**STAFF REPORT:** APRIL 13, 2022 MEETING  
**APPLICATION NUMBER:** 22-7748, 7749, 7750  
**ADDRESS:** 2224 - 2248 BURNS

**HISTORIC DISTRICT:** INDIAN VILLAGE  
**APPLICANT:** BLAINE RILEY  
**PROPERTY OWNER:** BLAINE RILEY  
**DATE OF PROVISIONALLY COMPLETE APPLICATION:** MARCH 21, 2022  
**DATE OF STAFF SITE VISIT:** MARCH 23, 2022

**SCOPE:** REPLACE FENCE AND GATE, REPLACE WINDOW WITH DOOR, ERECT STOOP

**Window/Door Opening**

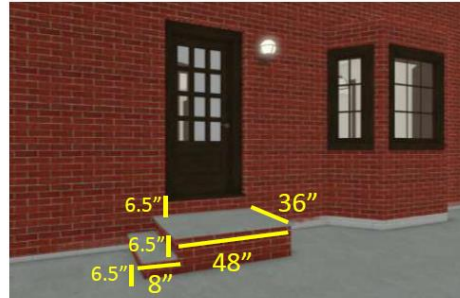
- The existing window unit proposed for removal is not character-defining, but the stone lintel above the window is a character-defining feature of the house.

- There are multiple sized openings on this elevation. It is staff’s opinion the alteration of the square opening for a wider/taller door is in keeping with the elevation’s patterning, and may offer a balance to the casement window opening on the other side of the bay window (as well as mimic the tall/short opening arrangement directly above at the second floor).
- As shown in the applicant’s mocked up photo (below right), the left edge of the door opening will match that of the existing window opening, allowing the vent, milk door and downspout to remain in place. It appears the header for the door may remain in line with the existing window header. If so, it is not clear if the applicant intends to retain the stone lintel.

- The selected solid oak and full glass door is of sympathetic age, however the proposal for the door to have a semi-transparent stain wood finish is not appropriate for an opening at this location on an English Revival-style house, as historic wood components are generally always painted.

- It is staff’s opinion that a semi-transparent stained wood front door can be an exception, as the contrast of finish can be appropriate for a main entrance. Staff noted the front door of this house is painted, and the side door will be positioned between banks of windows with painted sash and trim. Therefore, the secondary entrance would have the most prominent finish of all the window and door openings on the house and be in contrast with the remaining painted openings on the north side of the house. As the side elevation is adjacent the driveway and an empty lot, it is quite visible from the public right-of-way.

- The landing is specified at 36” wide by 48” deep. While it appears to HDC staff that the bay window extends less than 36” from the side wall, the applicant states the landing will not extend into the driveway.
- It is not clear if the applicant will remove the window opening’s stone lintel or leave it in place.

- The existing stone lintel of the window will remain in place to give evidence of the original opening.
- The wood door shall be painted dark reddish brown to match the front door and all other wood components.
- The side entry step and landing will not extend further from the wall than does the adjacent bay window, and will leave the existing driveway surface intact.
- The setback of the fence will be no closer to the sidewalk than the current fence, and could be set back further. The setback distance will be confirmed and added to the site plan for staff review.
- The wood fence and gate will be painted or stained in a solid stain in a color that compliments the adjacent house. The selected color will be submitted for staff review. The paint or stain will be applied after the wood has time to dry out, no earlier than May 2022 and no later than October 2022.

**New fence**

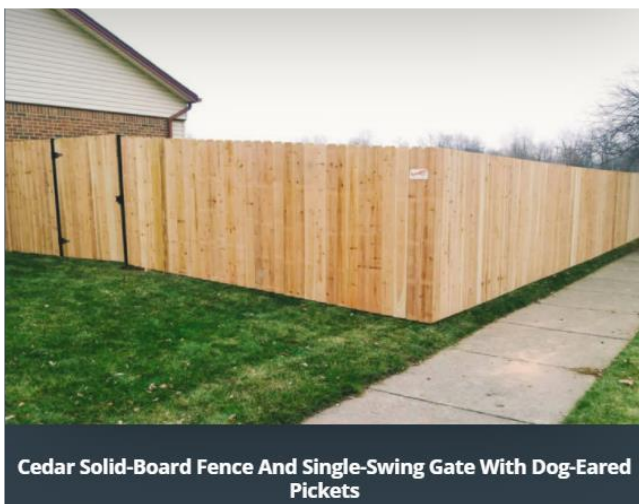
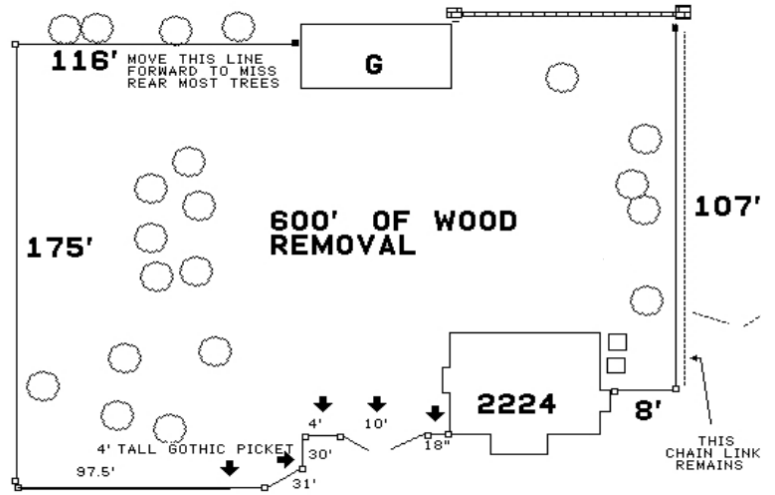
- Staff suspects the existing fence is a replacement of the one seen in the designation photo, as the one in place at time of designation had a top, center, and bottom rail. The current fence has a top and bottom rail. It is staff's opinion that the existing fence designs, while charming in a homespun way, are not character-defining features of the lots.

- The applicant’s proposal specifies the installation of a new fence in a similar arrangement as the existing fence. A 4’ tall picket fence (with 3-inch spacing between each picket) would enclose the side lot line adjacent to the house as well as along the Burns sidewalk. At the corner of Burns and E. Vernor, a 6’ tall solid board fence would run east to the corner of E. Vernor and the alley, and then continue south along the rear lot line. The double lined fence at the right corner of the rear yard denotes an existing brick wall that will remain in place.
- The proposed style and fencing material are consistent with the Fence and Hedge Guidelines and are appropriate to the district. The Guidelines allow for two types of fencing material on a single lot.

- The proposed light wood stain is a contemporary finish for fencing; the wood fence should be painted or stained with a solid stain in a darker color that complements the adjacent house. This is especially pertinent for this application as the fence abuts the house due to the driveway gate.
